PLAN COMMISSION MEETING NOTICE AND AGENDA Thursday, February 15, 2024 6:00 PM

REPORT TO THE PLAN COMMISSION

Project Name: Radiant Plastic Surgery Comprehensive Master Plan Amendment, Rezoning, and Site & Building Plan Review

Sheet:
Exterior Elevations

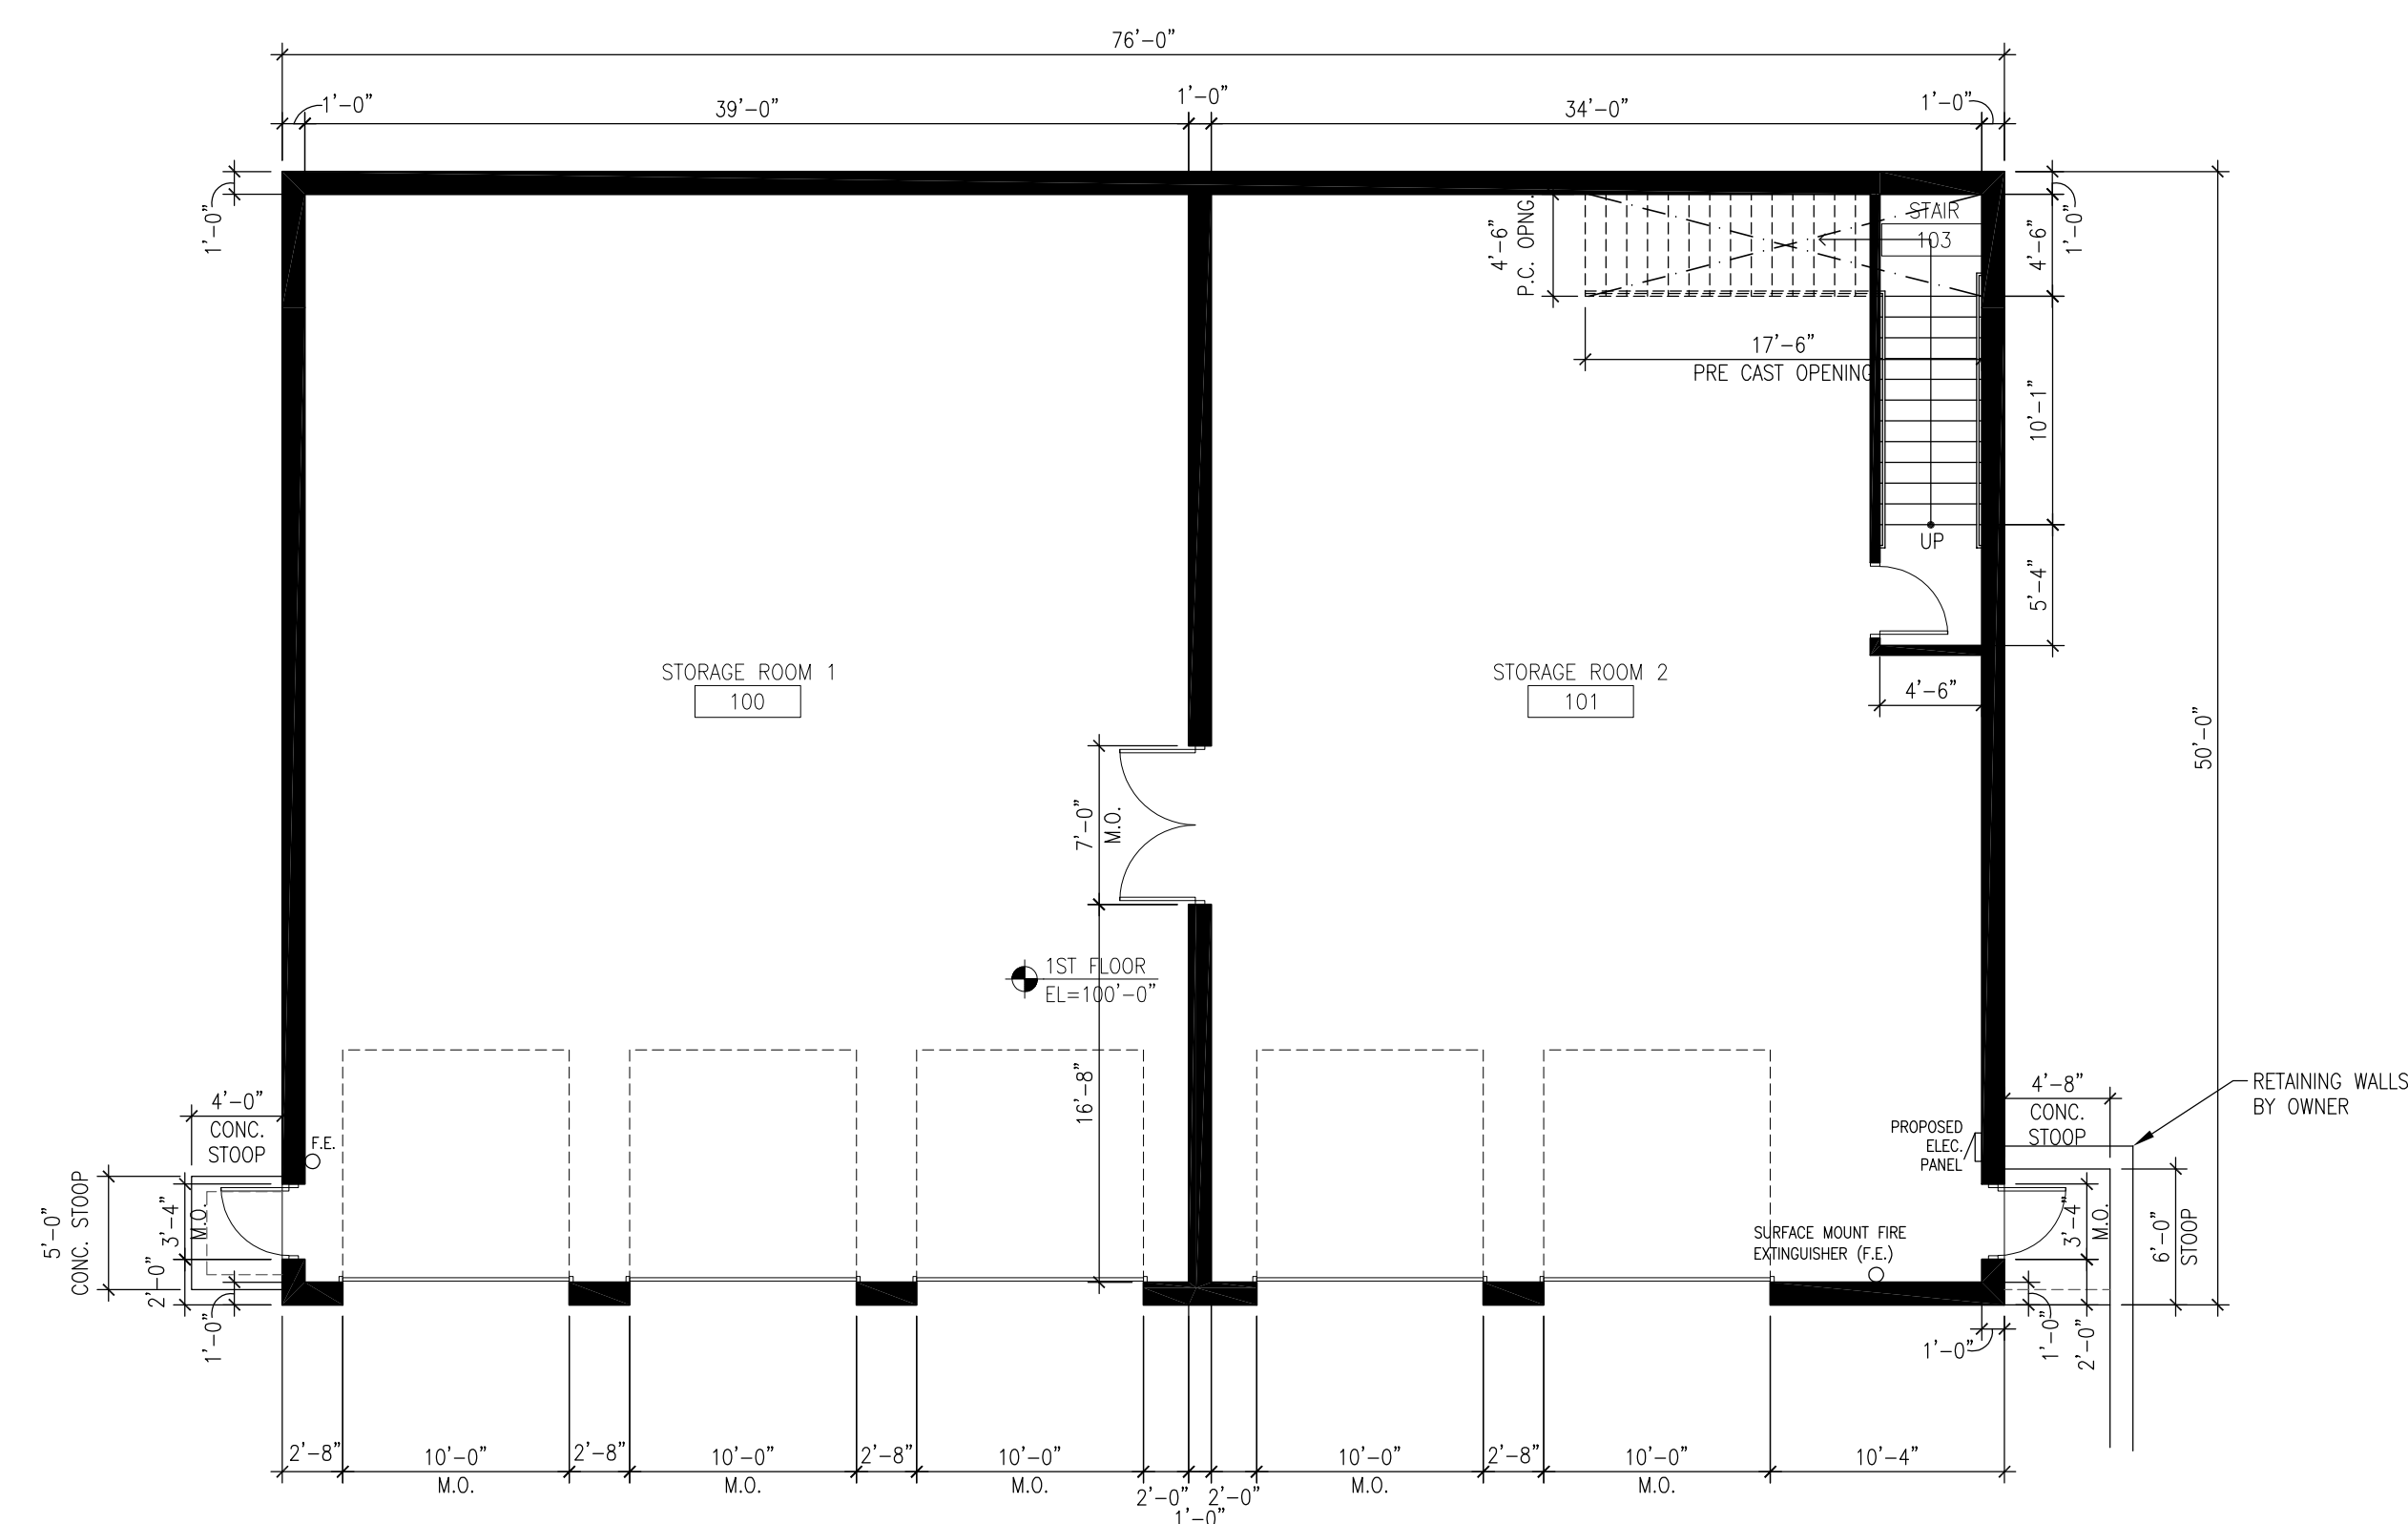
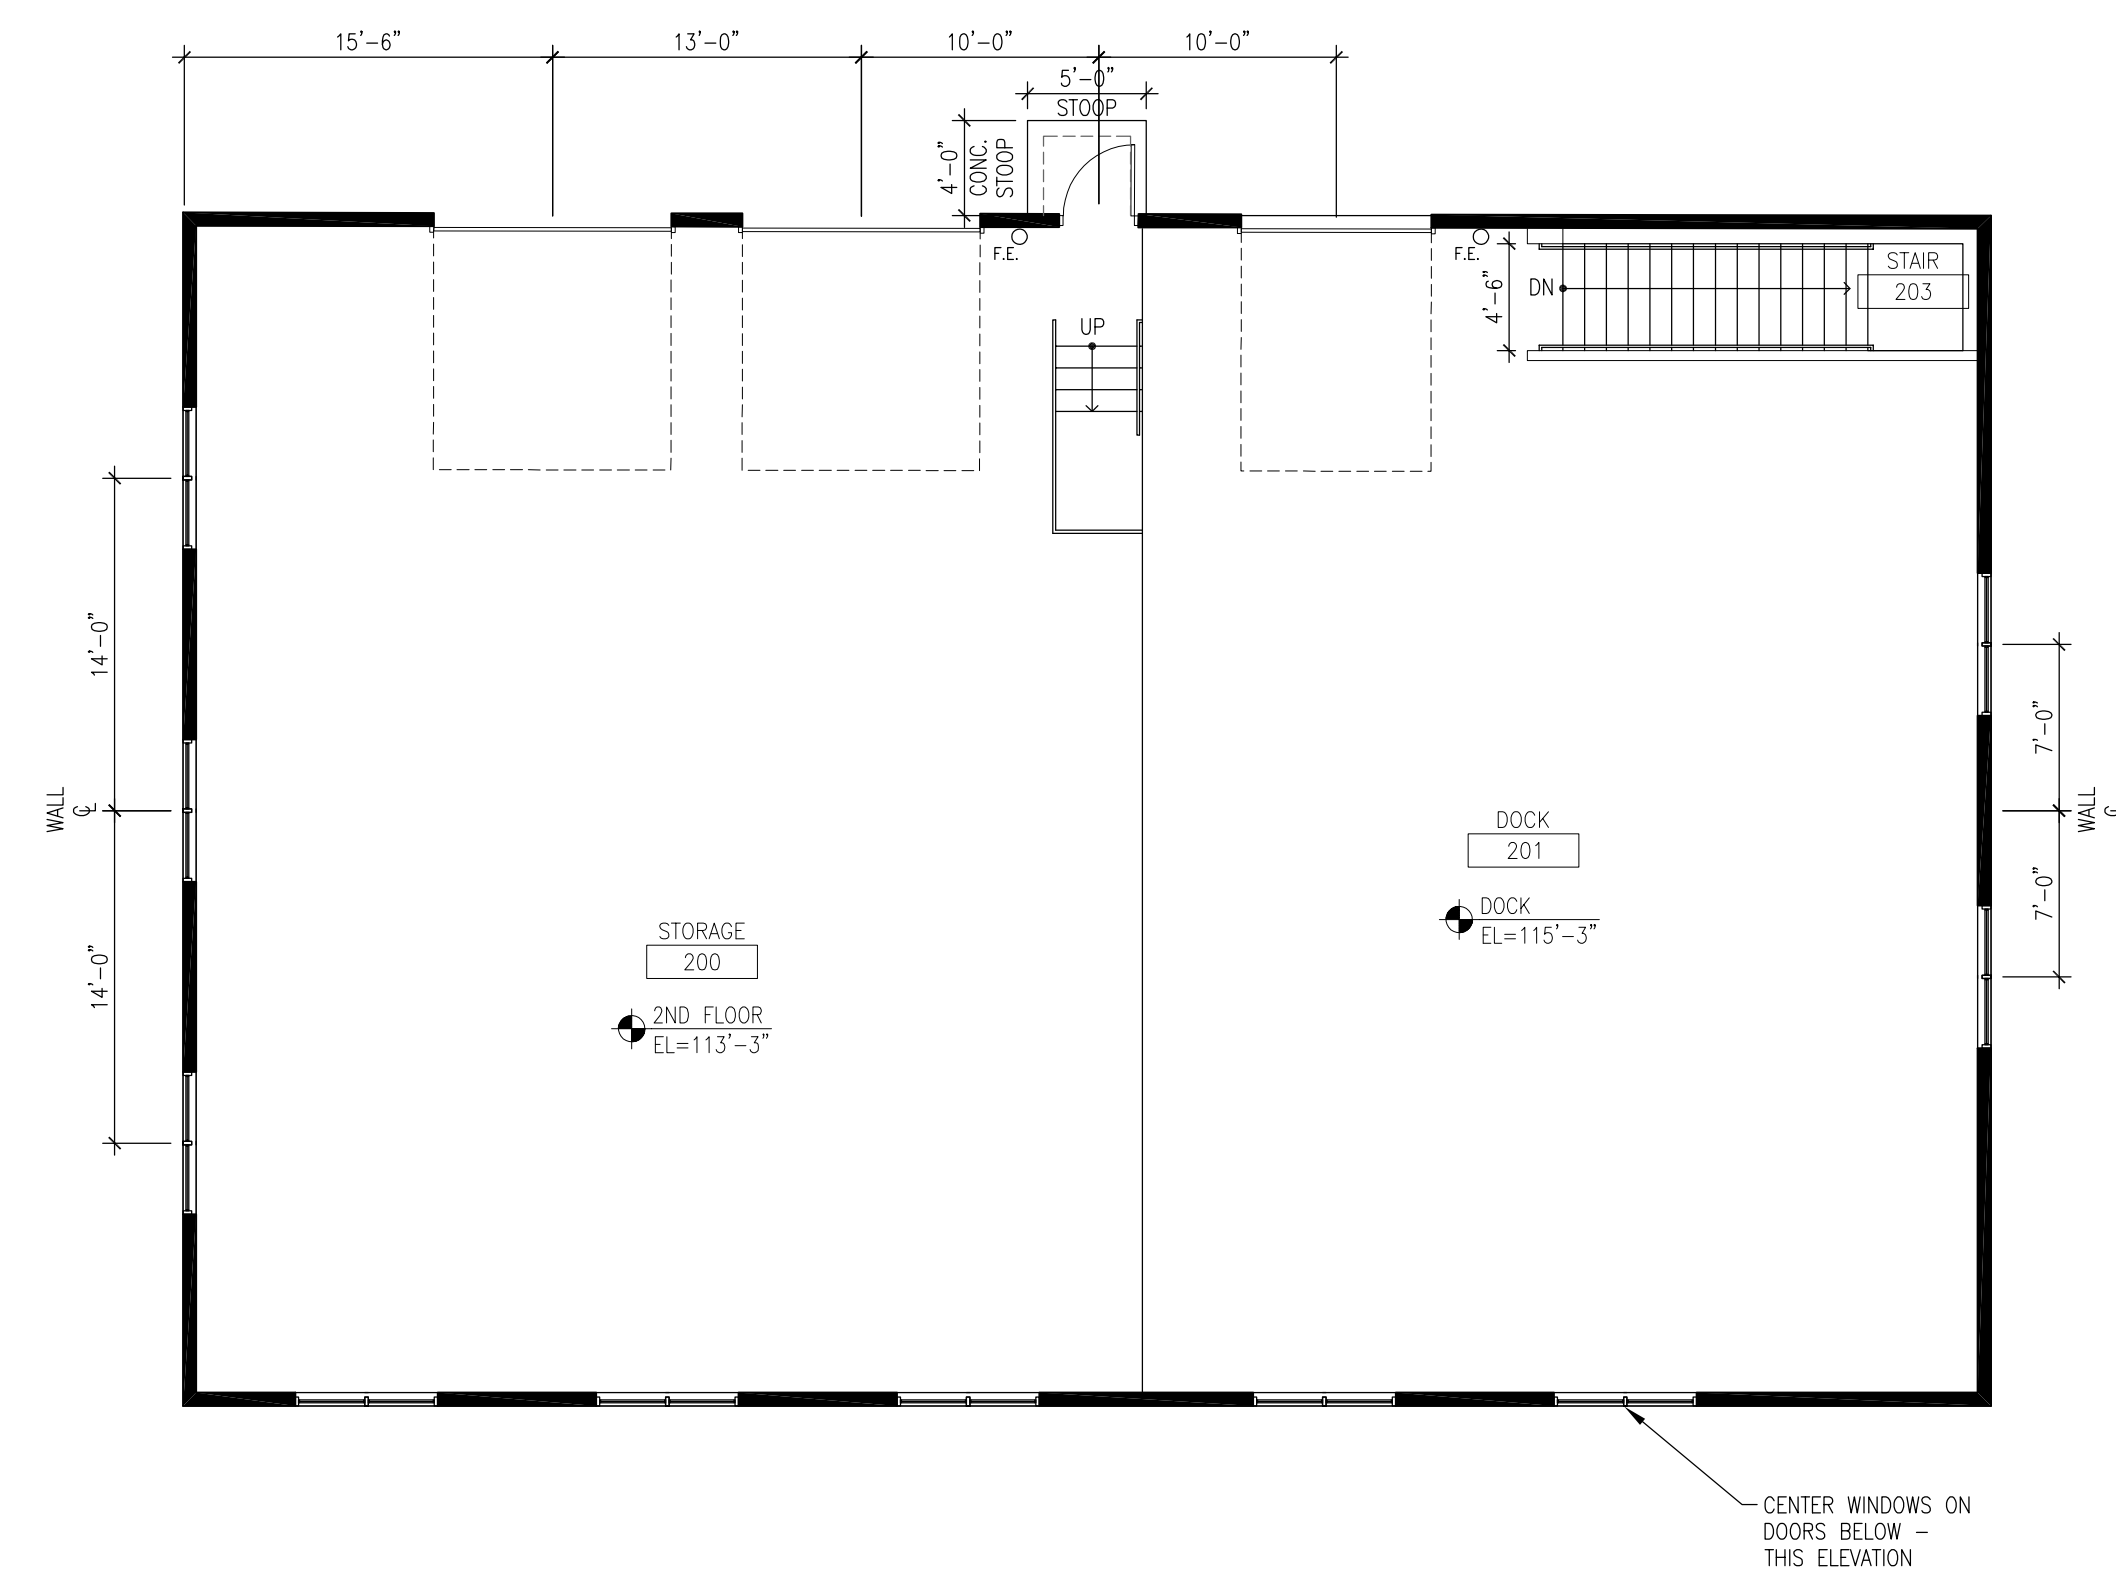
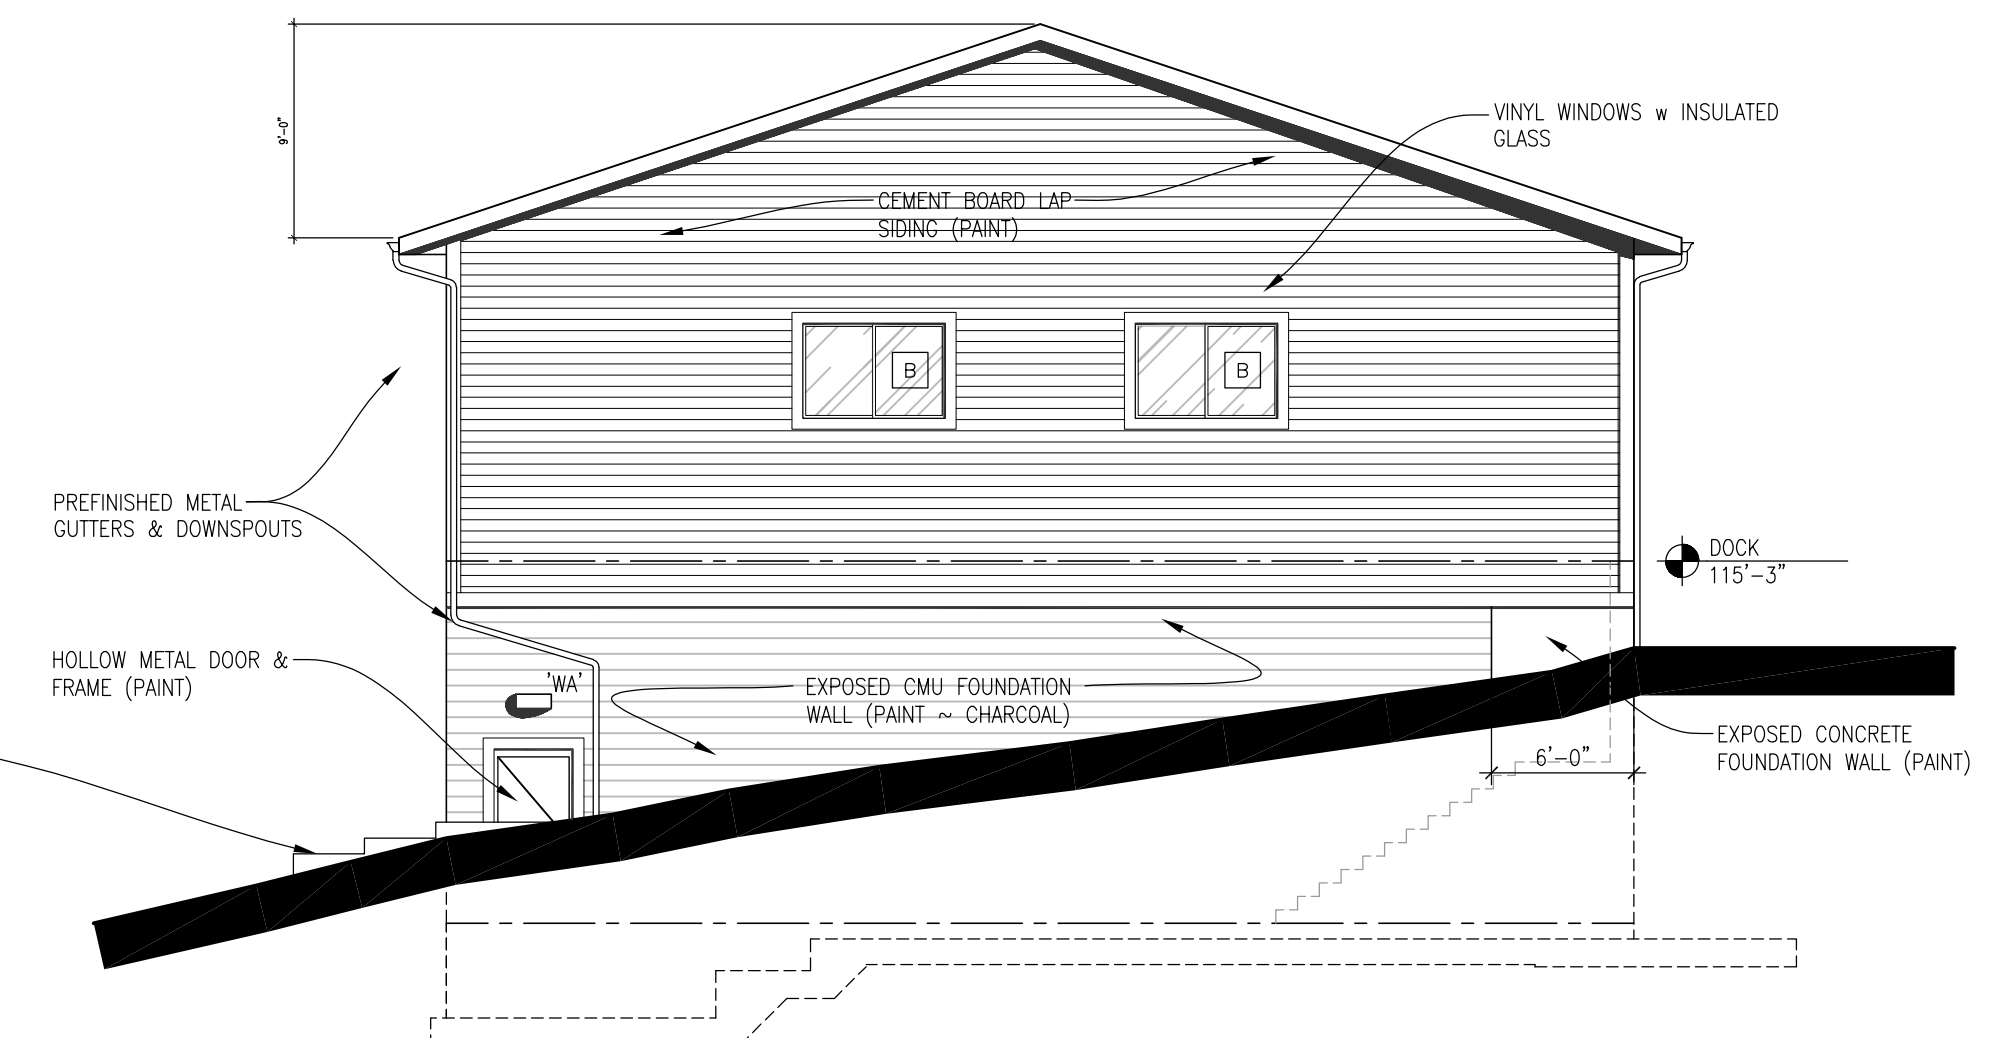
The building is currently under construction, and the applicant is now requesting allowance to increase the height of the building by 4-feet. In conjunction with this change, the height of the overhead garage doors on the north elevation will be two feet taller. Otherwise, building materials and number of doors and windows are not changing.

This request is to add 4ft of height to the building taking the second level wall height from 12ft to 16ft. The additional head space will allow more flexibility in storing some of our larger vehicles and materials.

Staff recommends approval of the request to increase the height of the storage building located at N4W22540 Bluemound Road by four feet as illustrated on the attached plans.
